ACCESS REPORT

DEVELOPMENT APPLICATION PHASE

RESTAURANT, SHOP 1

43-45 NORTH STEYNE, MANLY

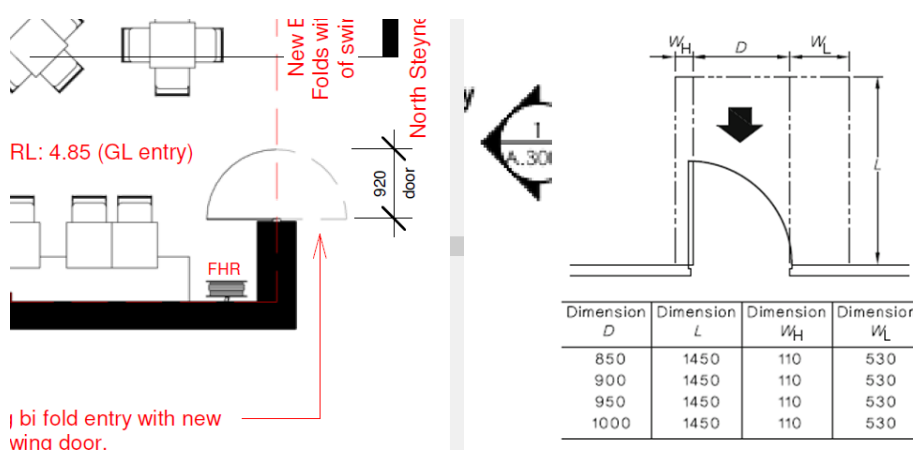
BCA Clause	Deemed-to-Satisfy Provision to be addressed																				
<u>D3.2 – Access to buildings</u>	<p>DTS Compliance Readily Achievable</p> <p>Main entry point is indicated as accessible as required.</p> <p>The main entry door below is to be shown with suitable hinge side clearance of 110mm at CC stage as below.</p> <div>
